Tactile Switch

June 28, 2012  
No. PCE-L-1206006

**Tactile Switch B3F-4 series  
Modification Notice of material change of plunger**

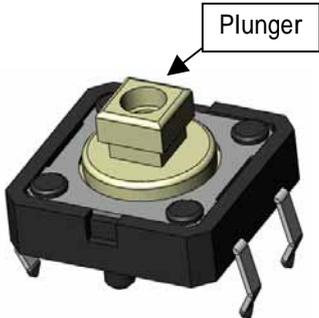
To improve heat resistance of plunger

Before the change	After the change
<p><b>Material change of plunger</b> Plunger material : ABS resin</p> 	<p><b>Material change of plunger</b> Plunger material : PBT resin</p> <p>No change of the outline drawing and the specification.</p>
